**STATE OF TENNESSEE  
DEPARTMENT OF TRANSPORTATION  
DESIGN DIVISION**

**INSTRUCTIONAL BULLETIN NO. 13-08**

**Regarding New and Revised Standard Drawings**

**Effective for the July 12<sup>th</sup> letting (May 1<sup>st</sup> turn-in),** the following Standard Drawings are new or revised and Section V of the Design Guidelines is revised for this update.

STANDARD STEEL GROUND MOUNTED SIGNS, BREAK-AWAY TYPE POST FOOTING DETAILS, I-BEAMS

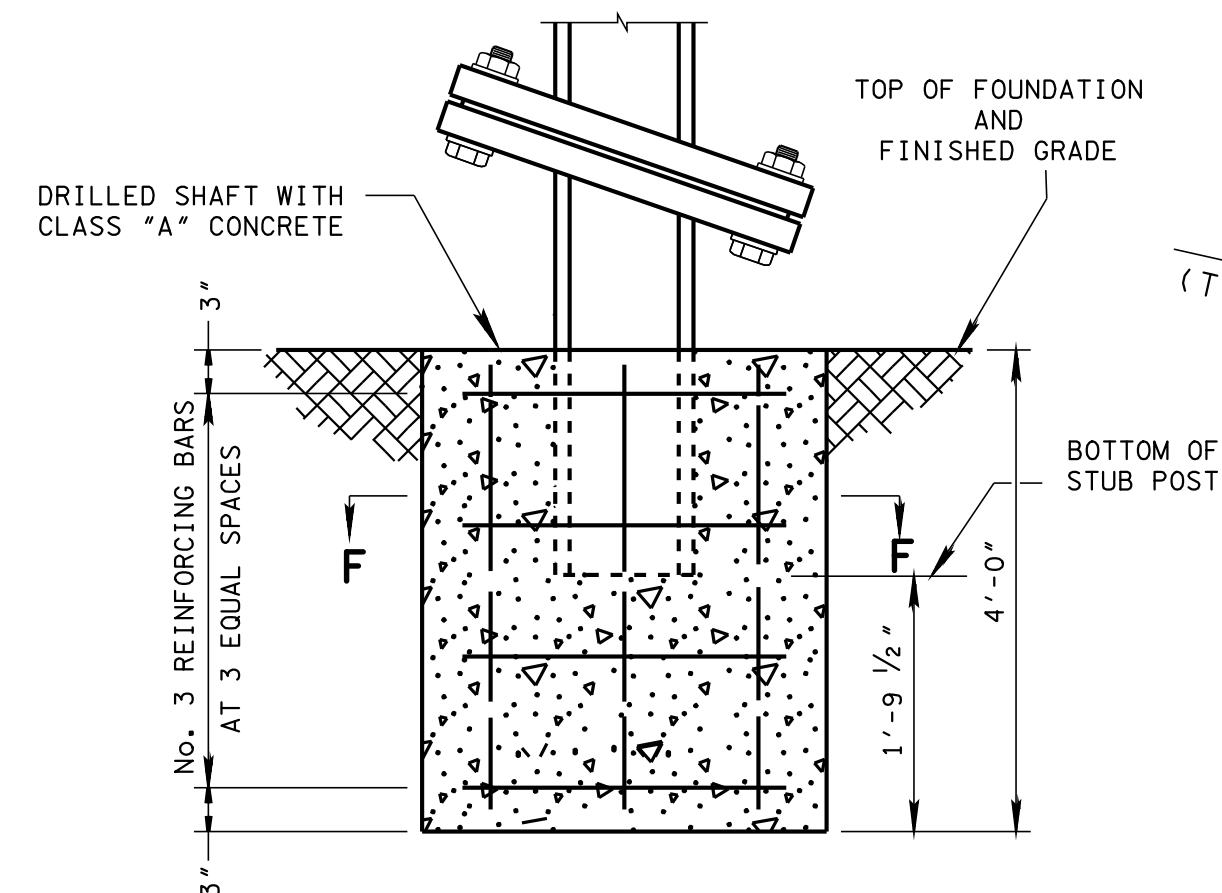
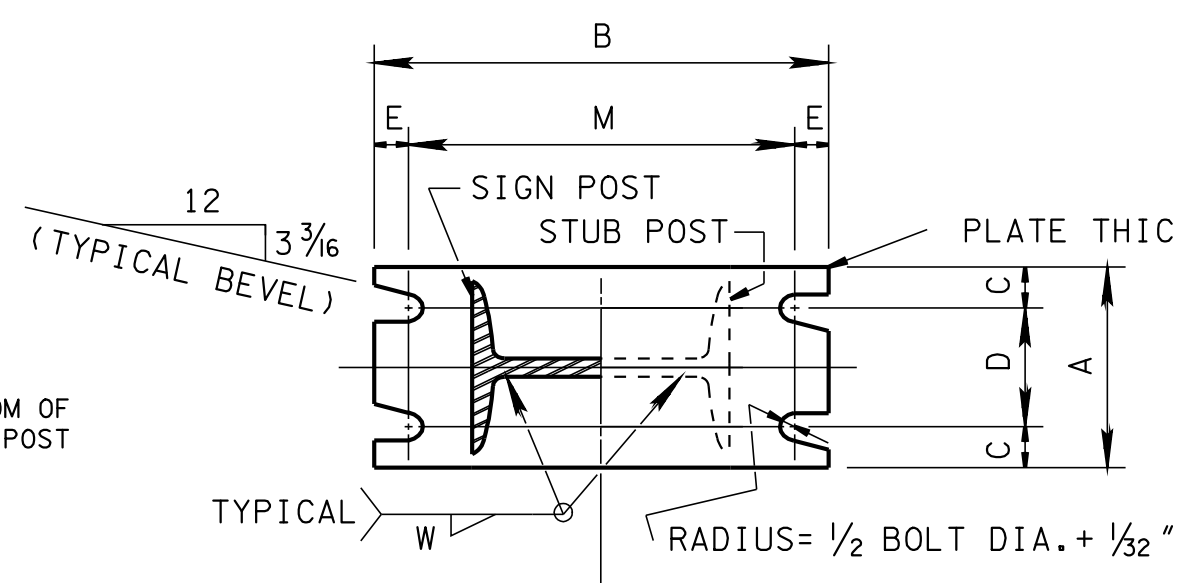
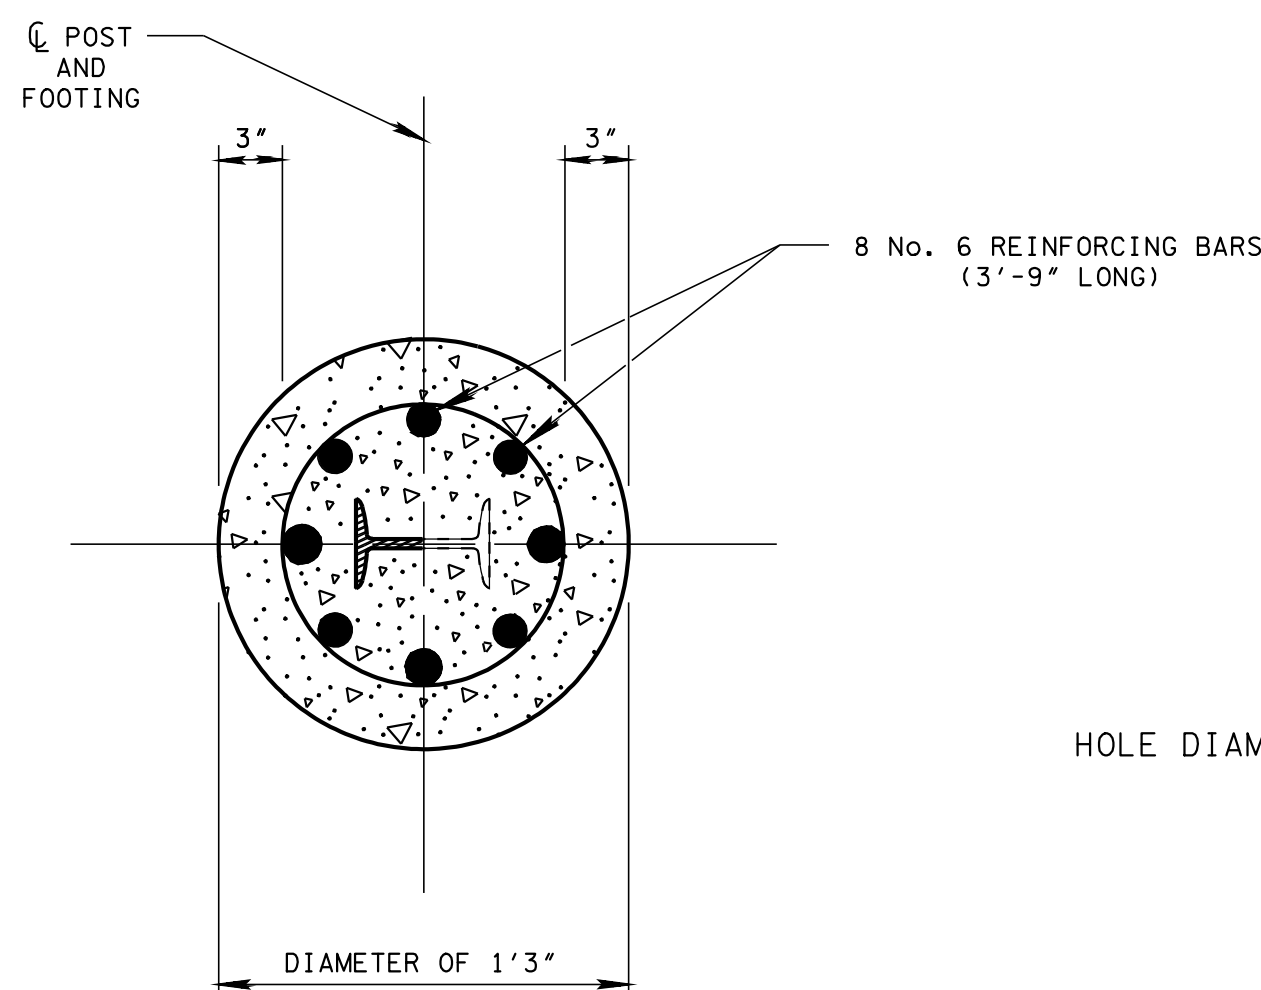
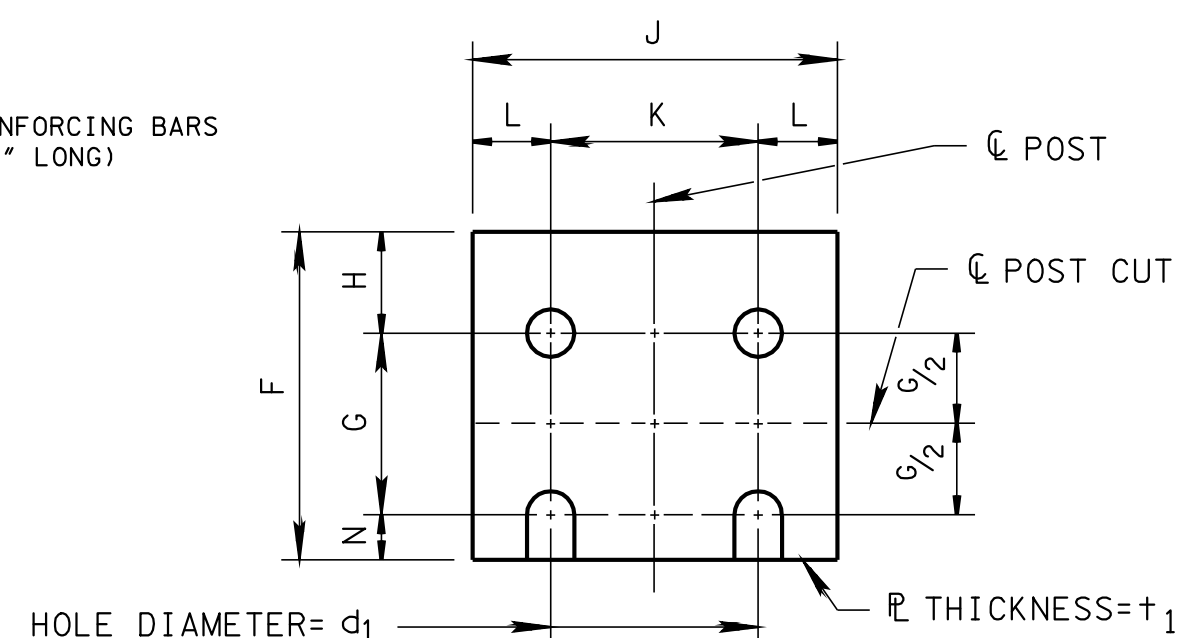
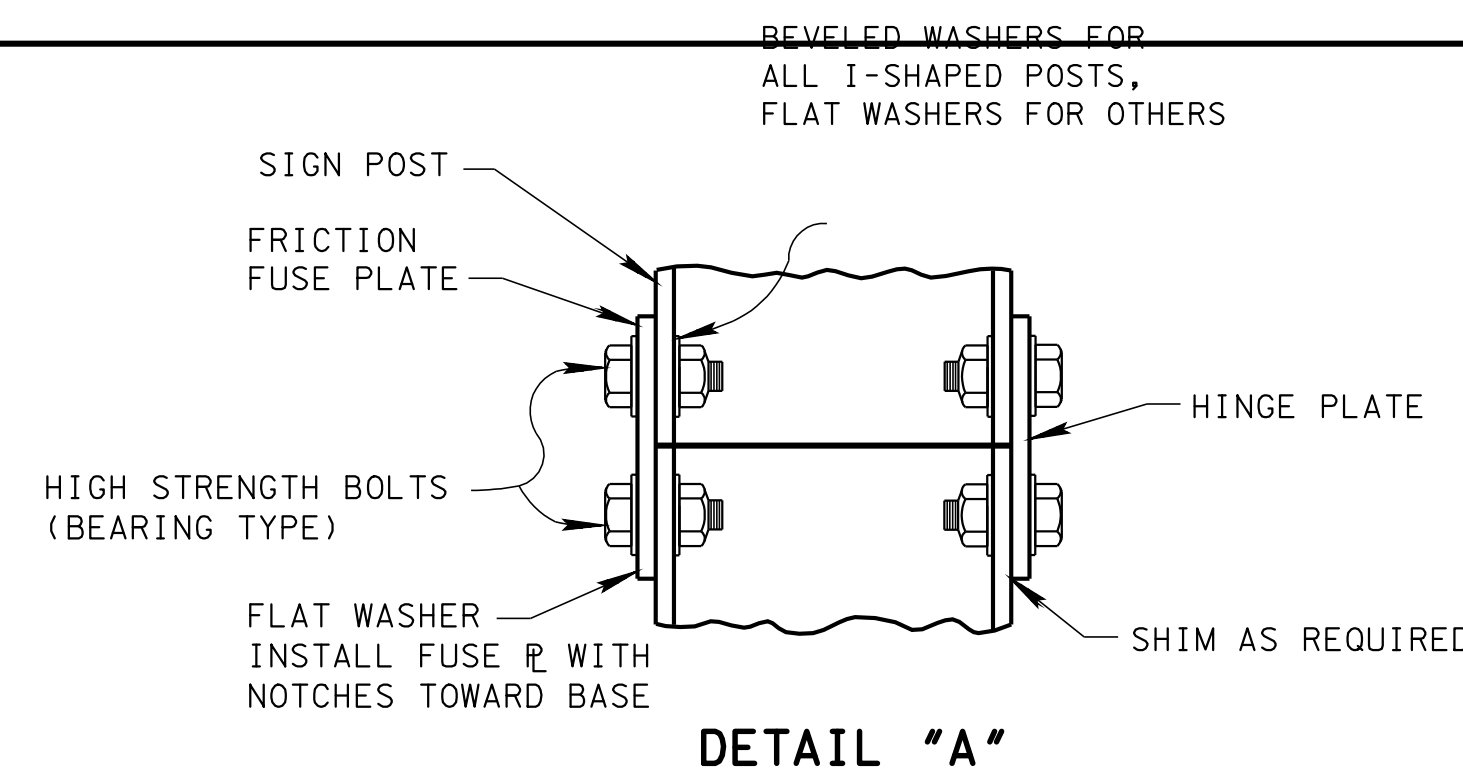
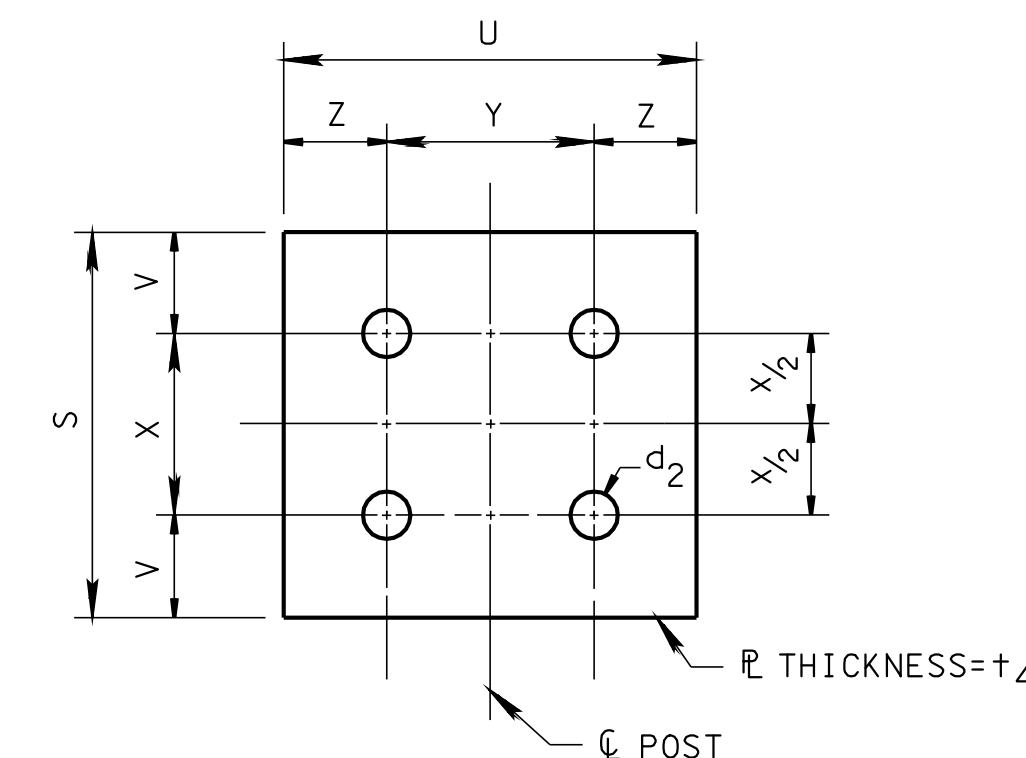
- REV. 10-26-96: CHANGED PAY ITEM NO. IN GENERAL NOTE (N).
- REV. 5-27-01: CHANGED NOTE UNDER SHIM DETAIL.
- REV. 7-20-12: REVISED DIMENSION K AND Y FOR S5X10.0.
